Report: PUNCH LIST
Function: Test, Adjust, & Balance
Date: 02/04/2026
Completed By: National TAB

PROJECT
02-02-26 CULVERS - CHARLOTTE, NC

Project Issue Information

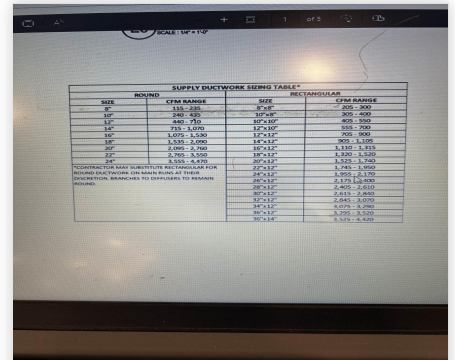
Issue Name : RTU-2 ductwork undersized
Description : RTU 2 is currently at 88% of design total flow. The ductwork from the unit was installed horizontally, this restricts the unit. On the MSET rooftop drawings refers to a note (M101) about proper ductwork size. Currently the supply ductwork 25x14 and also insulated inside. Supply pressure is at 1.50", the unit was at max amps 26.9a @61.5hz.

- **02/04/2026 National TAB - Jearod Ferrette**
 - The unit was slowed down by 2hz, to bring down the amps. Per the mechanical there is an email chain from Captive Air. The engineers wanted the unit to be ducted horizontally. This unit will be proportionally balance.
